SECTION 96 SUBMISSION

DEE WHY RSL CLUB - 932 PITTWATER ROAD
STAGE 5 CLUB EXTENSION

THIS PLAN TO BE READ IN CONJUNCTION WITH
MOD2018/0119
NORTHERN BEACHES COUNCIL

PROJECT:
STAGE 5 - CLUB EXTENSION
PHASE 2 WORKS - SOUTHERN
CARPARK & ENCLOSURE

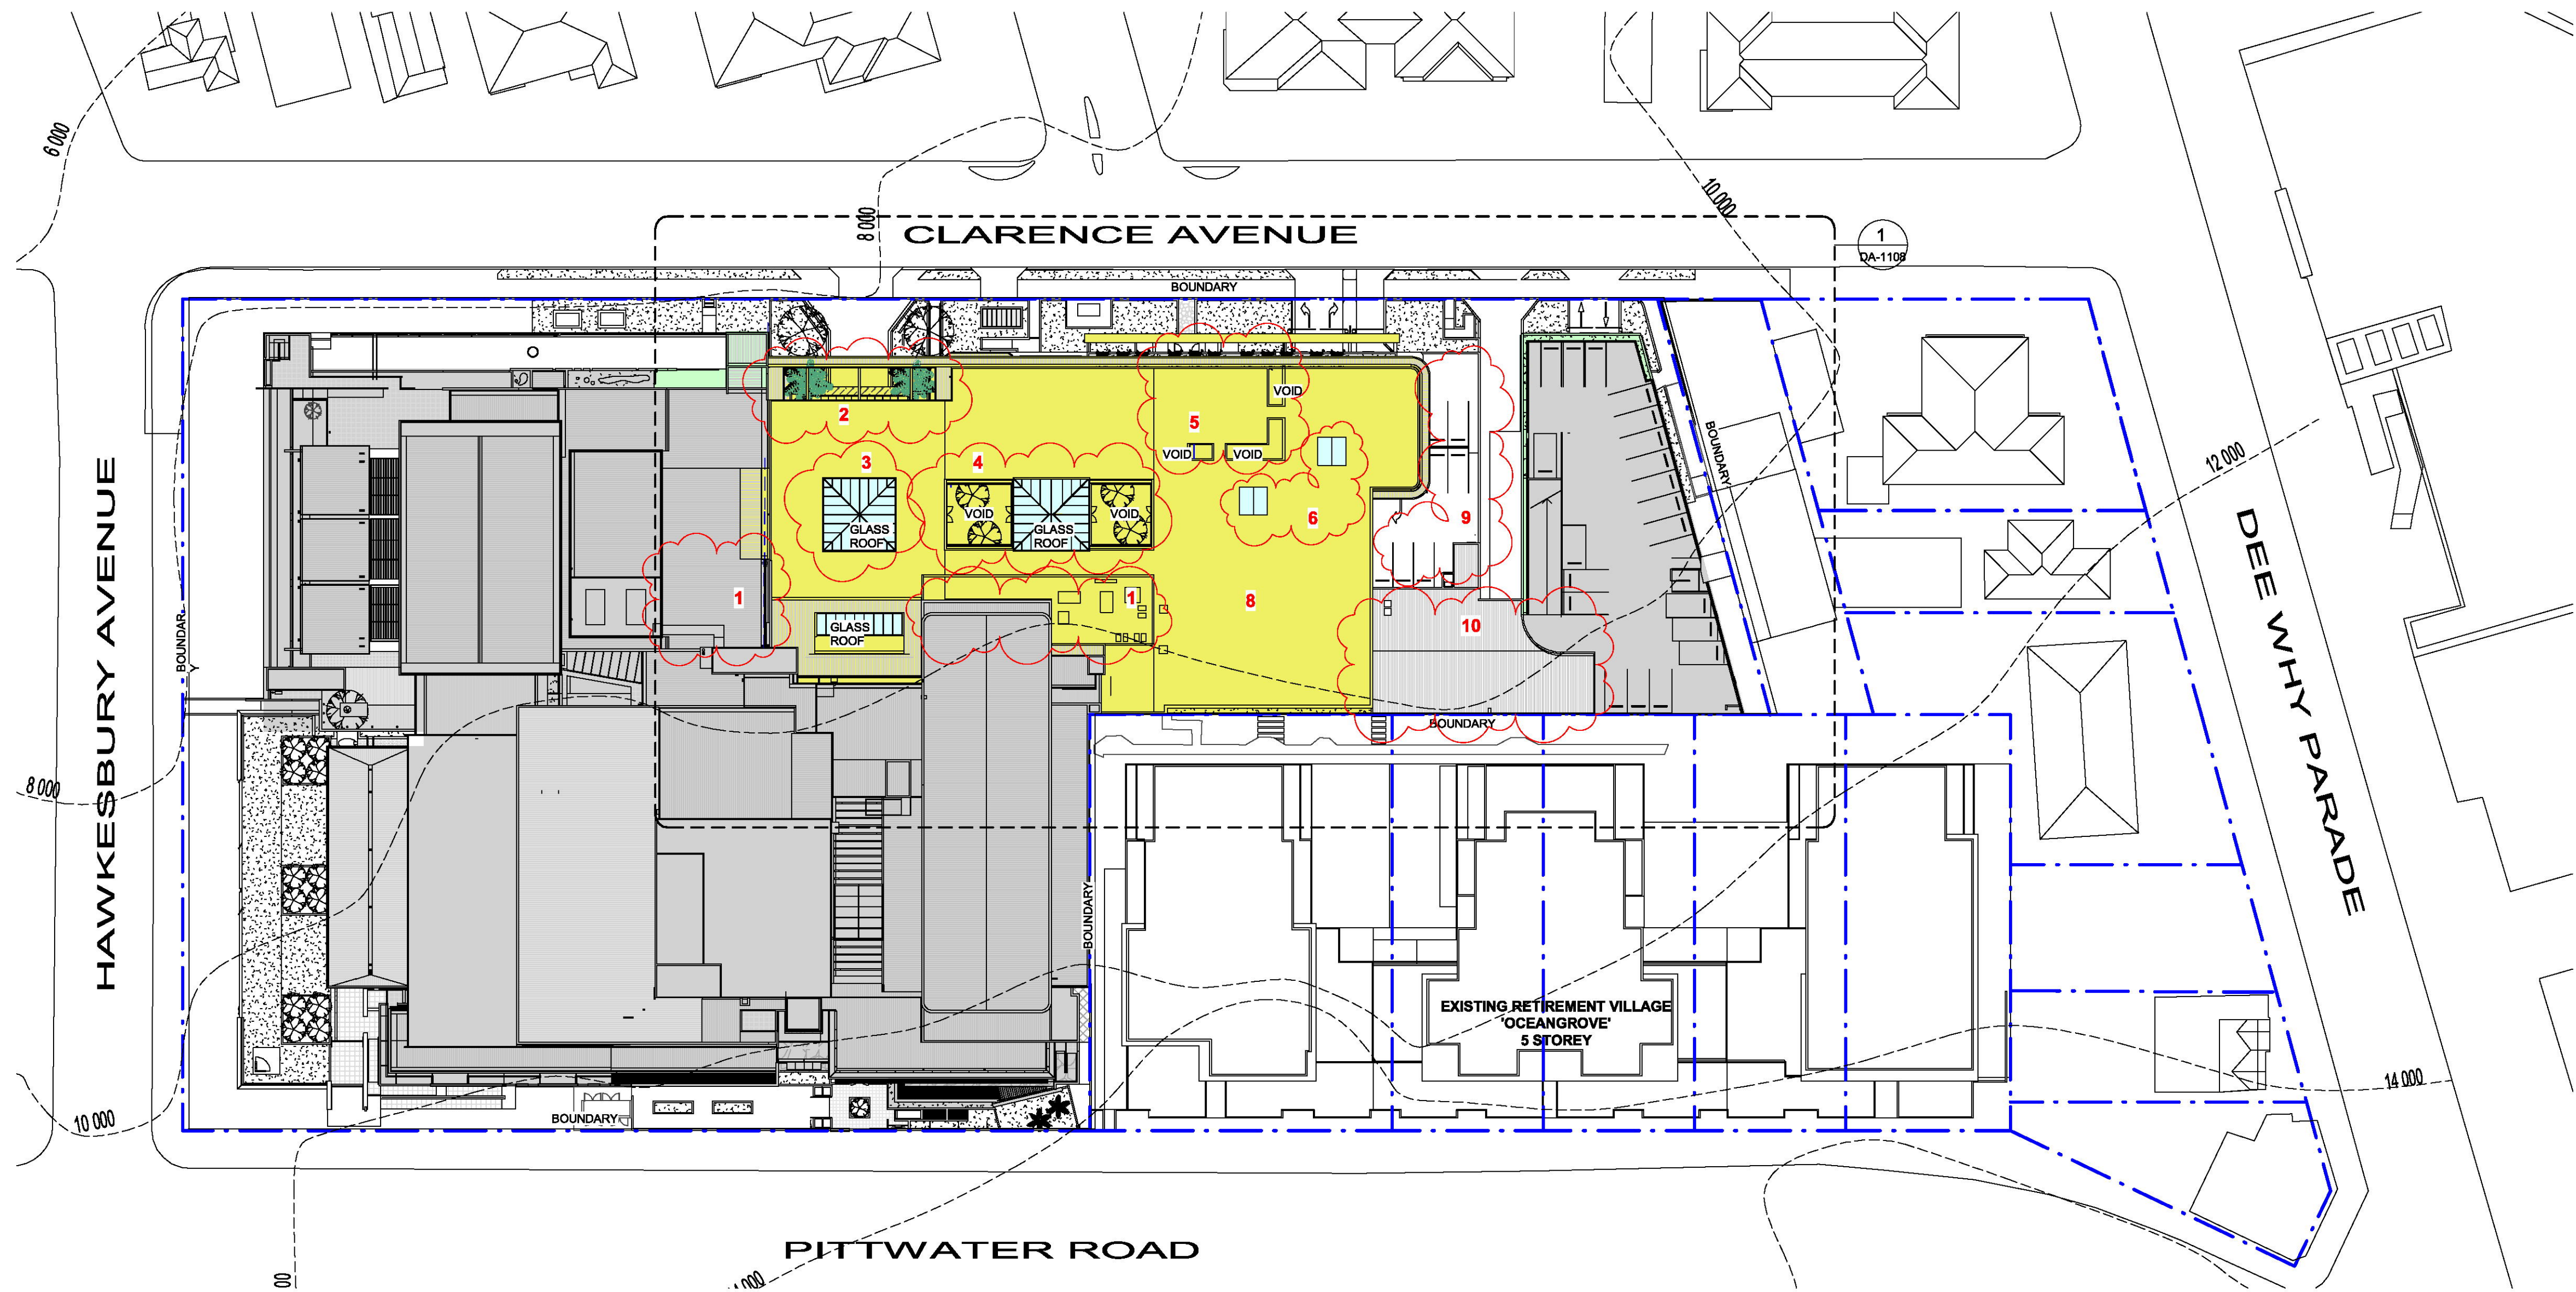
ISSUE	DATE	DESCRIPTION
1	17.03.2017	ISSUED FOR DEVELOPMENT APPLICATION
2	05.03.2018	ISSUED FOR SECTION 96
CHANGES FOR SECTION 96 APPROVAL		
roof		
1. RELOCATED OPEN PLANROOM AT THE ROOF LEVEL

2. MODIFIED ROOF OPENING ABOVE MAIN ENTRANCE		
3. MODIFIED CENTRAL SKYLIGHT (REDUCED HEIGHT, MODIFIED PITCH)		
4. MODIFIED COURTYARD: TWO OPEN COURTYARDS AND ONE SKYLIGHT COVERED AREA INSTEAD OF ONE LARGE GLASS ROOF. REDUCED HEIGHT AND PITCH

5. MODIFIED SMOKING TERRACE: ROOF OPENING, SIZE AND PLANTED AREA. AREA REDUCED BY 21m²		
6. REDUCED NUMBER OF ROOF SKYLIGHTS ABOVE ASIAN RESTAURANT: 2 INSTEAD OF 6 TO SUIT THE NEW INTERNAL LAYOUT

7. MODIFIED EXIT STAIR: POSITION, CONFIGURATION, METAL ROOF NO LONGER REQUIRED		
8. CONCRETE ROOF INSTEAD OF METAL DECK ROOF FOR THE MAJORITY OF THE BUILDING EXTENSION

9. NO SLAB ABOVE THE EXPOSED CAR PARK LEVEL 2 IN THE SOUTH AREA		
10. NEW ACOUSTIC METAL ROOF ABOVE REVISED LOADING DOCK		
facade		
11. MODIFIED FACADE APPEARANCE DUE TO CHANGES IN THE CAR PARK LEVELS, LOADING DOCK AND EGRESS STAIRS

12. REMOVED LOUVRES ON THE BACK FACADE (WESTERN FACADE) DUE TO MECHANICAL RISER NO LONGER REQUIRED / REVISED LOCATION FOR EGRESS DOORS		
13. 2m WIDE INTERNAL EGRESS STAIR MODIFIED INTO TWO 1m WIDE EXTERNAL STAIRS WITH DECORATIVE BALUSTRADES

14. EXTENT OF LEVEL 2 (MAIN TRADING LEVEL) REDUCED BY 8328mm FROM THE SOUTHERN BOUNDARY AND INCREASED BY 1100mm TO THE EASTERN BOUNDARY		
15. MODIFIED FACADE CURTAIN WALL MULLION BLADES

18. REVISED LOADING DOCK ENTRANCE AND LOCATION/ ENLARGED DEMOLISHED AREA IN THE EXISTING RETAINED SOUTHERN CAR PARK		
19. NEW / MODIFIED EGRESS PATHS FROM EXISTING CARPARK LEVEL -1. NEW CARPARK LEVEL 1.

20. RELOCATED ELECTRICAL SUBSTATION / LANDSCAPED AREA MOVED TO SUIT		
21. MEDIAN STRIP ADDED AT ENTRY TO PROVIDE PLACE OF REFUGE AND ENSURE WIDTH OF ENTRY/ EXIT IS LESS THAN 8M AS PER DA CONDITION 23

24. BASEMENT CAR PARK LEVEL -5 ADDED.		
25. CAR PARK ENTRY / EXIT MOVED TOWARD NORTH BY 3044mm		
26. PLANTER MODIFIED ON THE BACK (WESTERN) FACADE DUE TO REDUCTION OF THE MAIN TRADING FLOOR SLAB

27. LOCATION OF AIR INTAKE MODIFIED		
28. EXTENT OF RESTAURANT REDUCED BY 136m²		
29. CLUB ENTRANCE ACCESSIBLE RAMPS MODIFIED		
30. ONE ADDITIONAL EXISTING CAR PARK SPACE TO BE REMOVED FROM EXISTING NORTHERN CAR PARK

31. SOLID MASONRY WALL ADDED BETWEEN EXISTING ZONE D CAR PARK AND LOADING DOCK ACCESS.		
NEW CLUB AND CAR PARK		
ALTERATIONS TO EXISTING CLUB AND CAR PARK		
NO NEW WORKS TO EXISTING CLUB		
CLIENT:		
DEE WHY RSL CLUB		
PROJECT:		
STAGE 5 - CLUB EXTENSION PHASE 2 WORKS - SOUTHERN CARPARK & ENCLOSURE		
ARCHITECT:		
ALTIS architecture p 61 2 9364 9000 f 61 2 9571 7930 lower deck jones bay wharf suite 123 / 26 - 32 pirrama road pyrmont nsw 2009 australia

DRAWING TITLE:
CAR PARK LEVEL -4 & LEVEL -5

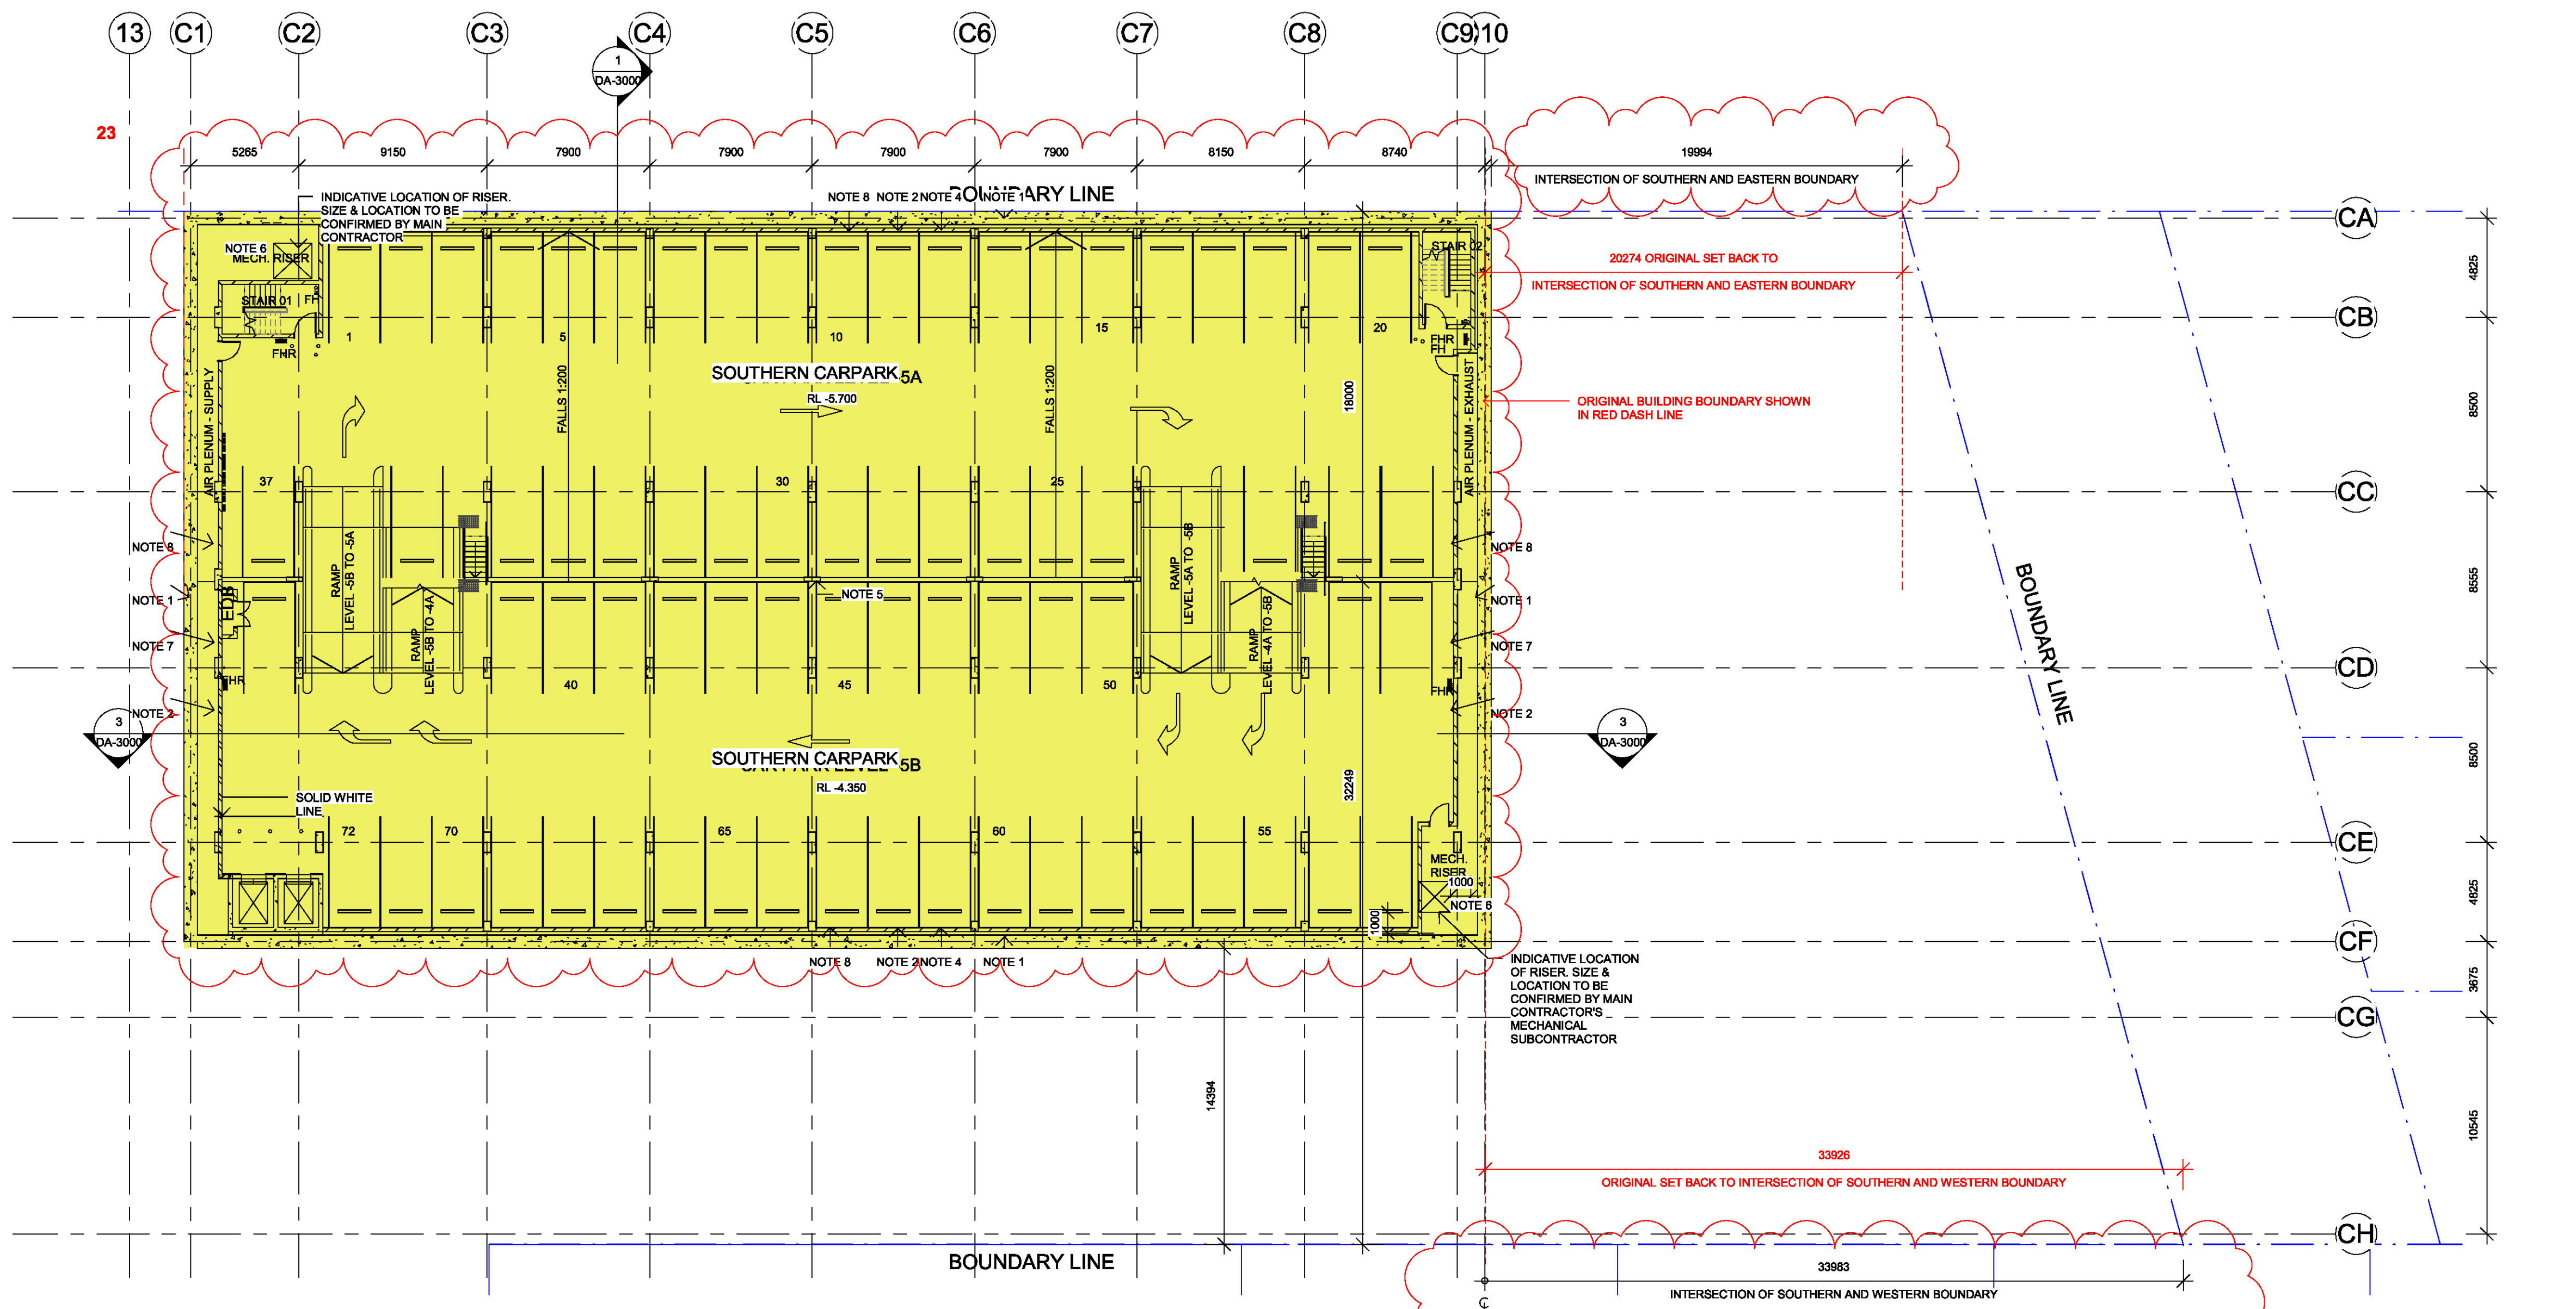
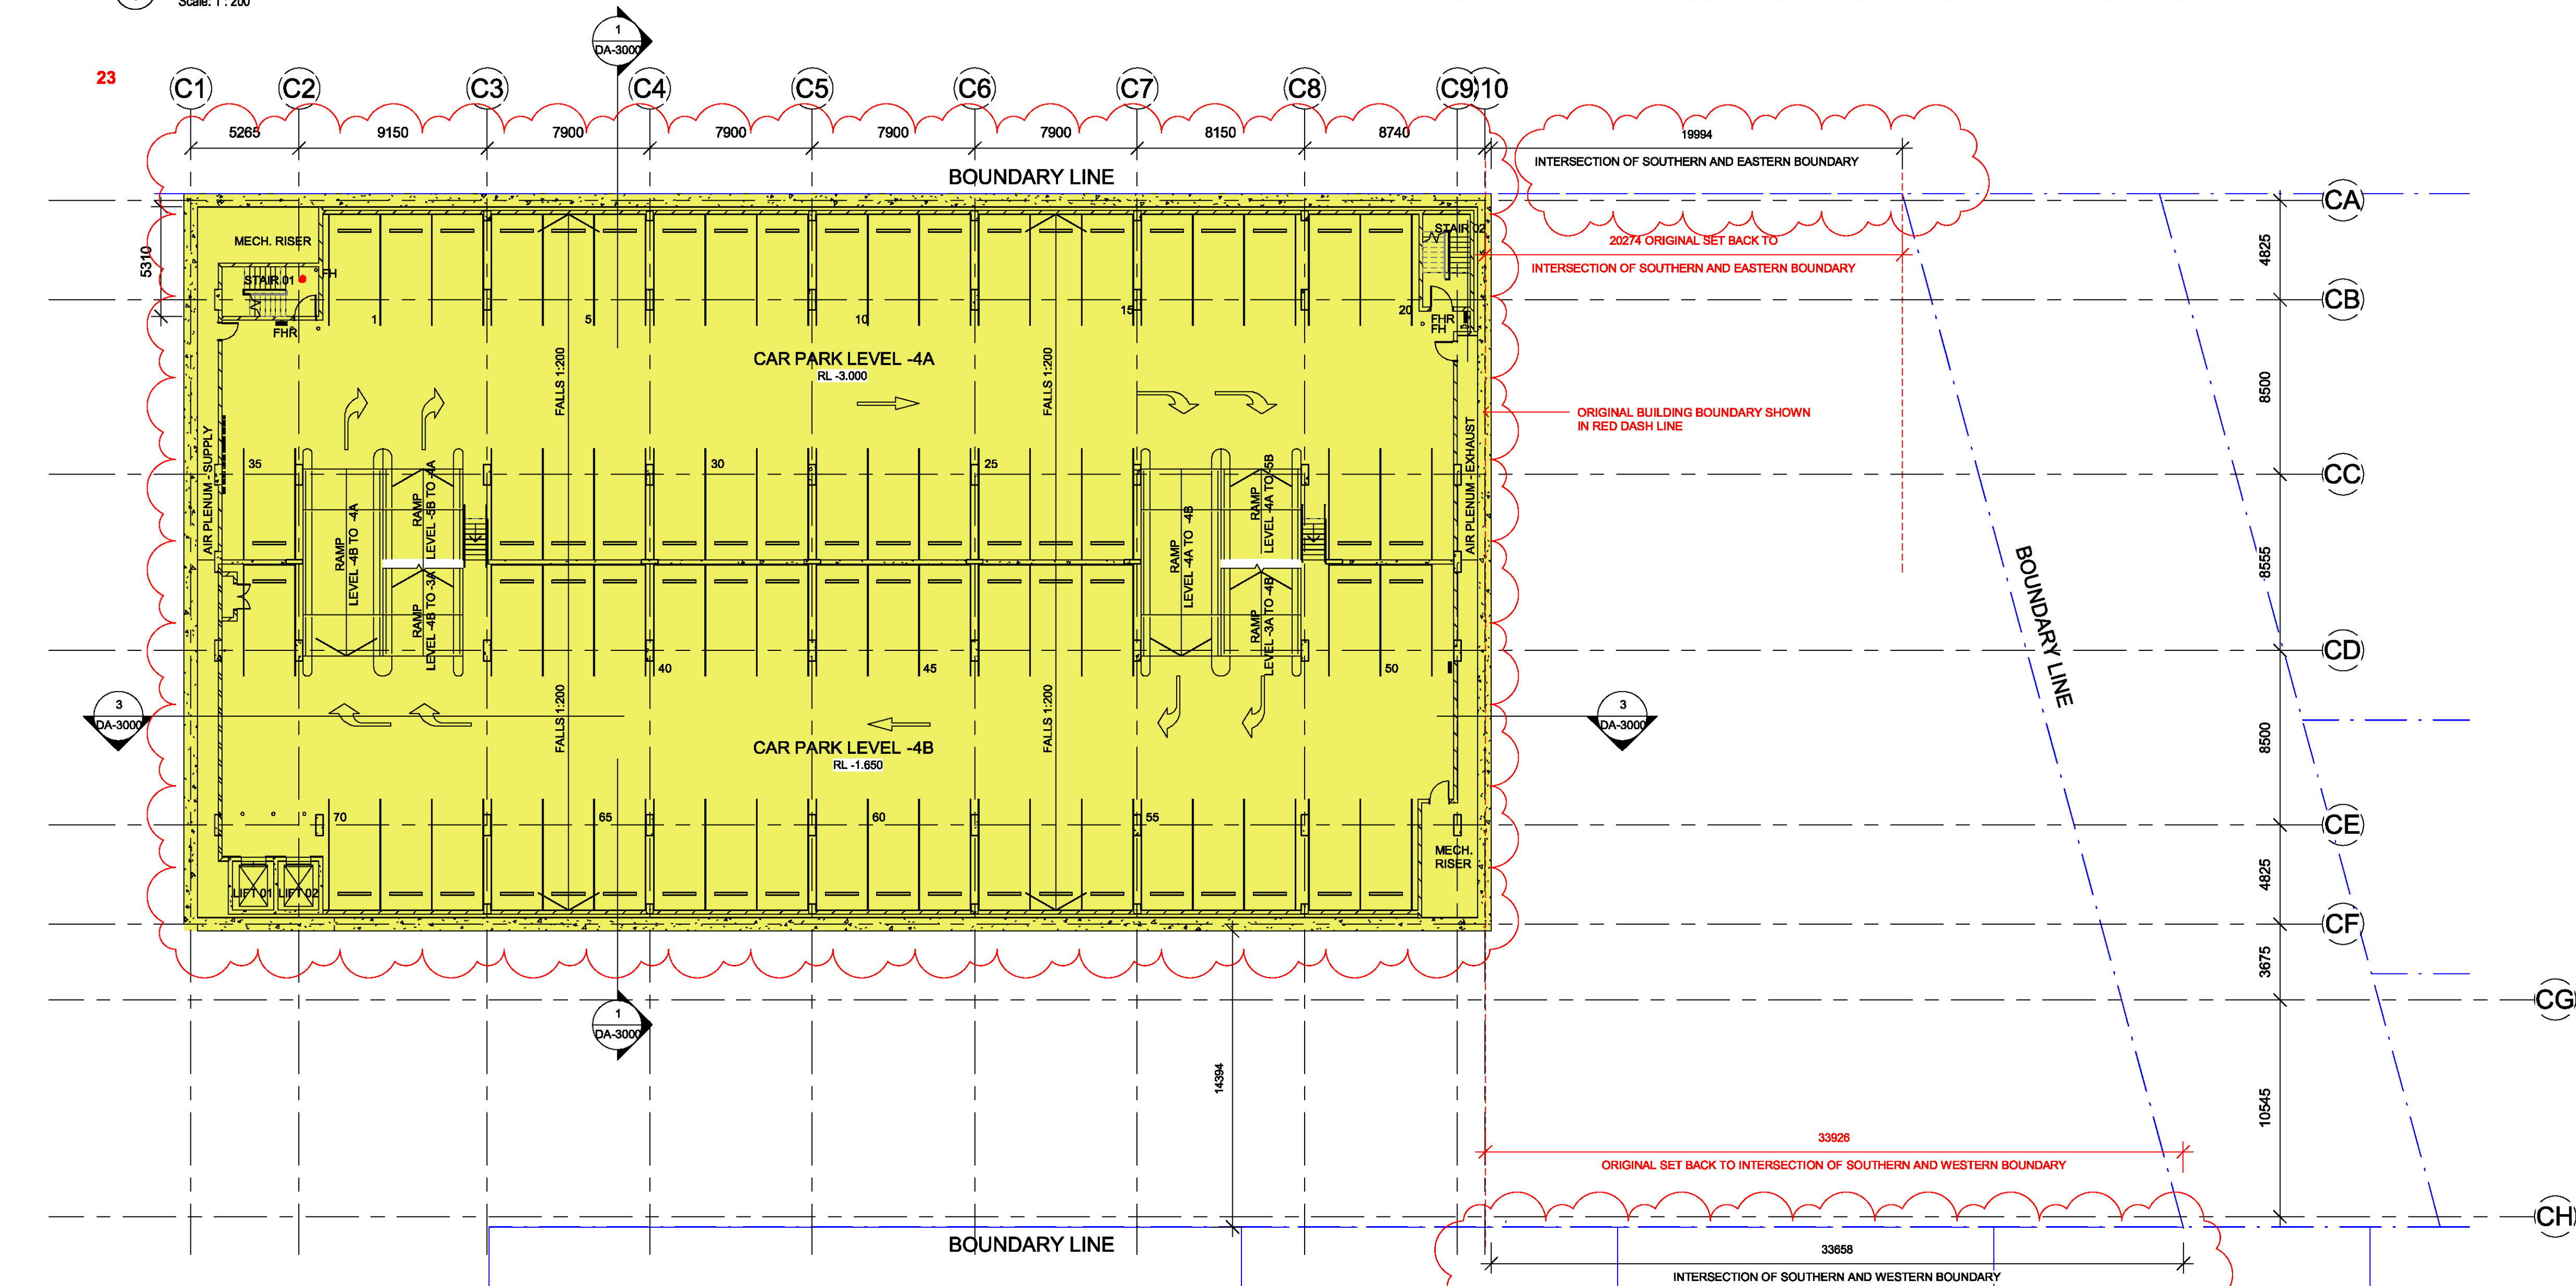
- CHANGES FOR SECTION 98 APPROVAL**
- roof**
1. RELOCATED OPEN PLANTROOM AT THE ROOF LEVEL
 2. MODIFIED ROOF OPENING ABOVE MAIN ENTRANCE
 3. MODIFIED CENTRAL SKYLIGHT (REDUCED HEIGHT, MODIFIED PITCH)

4. MODIFIED COURTYARD: TWO OPEN COURTYARDS AND ONE SKYLIGHT COVERED AREA INSTEAD OF ONE LARGE GLASS ROOF, REDUCED HEIGHT AND PITCH
 5. MODIFIED SMOKING TERRACE: ROOF OPENING, SIZE AND PLANTED AREA, AREA REDUCED BY 21m²

6. REDUCED NUMBER OF ROOF SKYLIGHTS ABOVE ASIAN RESTAURANT: 2 INSTEAD OF 6 TO SUIT THE NEW INTERNAL LAYOUT
 7. MODIFIED EXIT STAIR: POSITION, CONFIGURATION, METAL ROOF NO LONGER REQUIRED

10. NEW ACOUSTIC METAL ROOF ABOVE REVISED LOADING DOCK
- facade**
11. MODIFIED FACADE APPEARANCE DUE TO CHANGES IN THE CAR PARK LEVELS, LOADING DOCK AND EGRESS STAIRS

12. REMOVED LOUVRES ON THE BACK FACADE (WESTERN FACADE) DUE TO MECHANICAL RISER NO LONGER REQUIRED / REVISED LOCATION FOR EGRESS DOORS
 13. 2m WIDE INTERNAL EGRESS STAIR MODIFIED INTO TWO 1m WIDE EXTERNAL STAIRS WITH DECORATIVE BALUSTRADES

14. EXTENT OF LEVEL 2 (MAIN TRADING LEVEL) REDUCED BY 5328mm FROM THE SOUTHERN BOUNDARY AND INCREASED BY 100mm TO THE EASTERN BOUNDARY
 15. MODIFIED FACADE CURTAIN WALL MULLION BLADES

- ground/landscape/floor plate**
18. REVISED LOADING DOCK ENTRANCE AND LOCATION/ ENLARGED DEMOLISHED AREA IN THE EXISTING RETAINED SOUTHERN CAR PARK
 19. NEW / MODIFIED EGRESS PATHS FROM EXISTING CARPARK LEVEL -1. NEW CARPARK LEVEL 1.

20. RELOCATED ELECTRICAL SUBSTATION / LANDSCAPED AREA MOVED TO SUIT
 21. MEDIAN STRIP ADDED AT ENTRY TO PROVIDE PLACE OF REFUGE AND ENSURE WIDTH OF ENTRY/ EXIT IS LESS THAN 8M AS PER DA CONDITION 23

24. BASEMENT CAR PARK LEVEL -5 ADDED.
 25. CAR PARK ENTRY / EXIT MOVED TOWARD NORTH BY 3044mm
 26. PLANTER MODIFIED ON THE BACK (WESTERN) FACADE DUE TO REDUCTION OF THE MAIN TRADING FLOOR SLAB

27. LOCATION OF AIR INTAKE MODIFIED
 28. EXTENT OF RESTAURANT REDUCED BY 136m²
 29. CLUB ENTRANCE ACCESSIBLE RAMPS MODIFIED
 30. ONE ADDITIONAL EXISTING CAR PARK SPACE TO BE REMOVED FROM EXISTING NORTHERN CAR PARK

31. SOLID MASONRY WALL ADDED BETWEEN EXISTING ZONE D CAR PARK AND LOADING DOCK ACCESS.
